Аррис. №0.: 10/062,049 Amdt. Dated January 31, 2005

Reply to Office action of November 5, 2004

Amendment to the drawings:

FIG 1

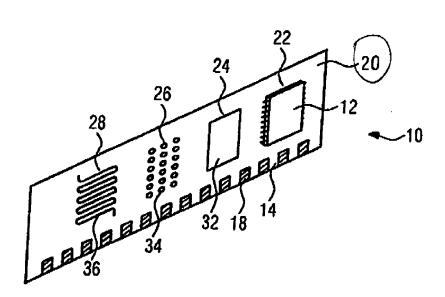
The attached sheets of drawings include changes to Figs. 1-3. These sheets replace the original sheets. In Figs. 1 and 2, previously omitted reference sign 20 has been added. In Fig.

In item 2 on page 2 of the above-identified Office action, the drawings have been objected to under 37 CFR 1.84(p)(5) as not showing the reference sign 20 mentioned in the specification.

The reference sign 20 has been added to Figs. 1 and 2.
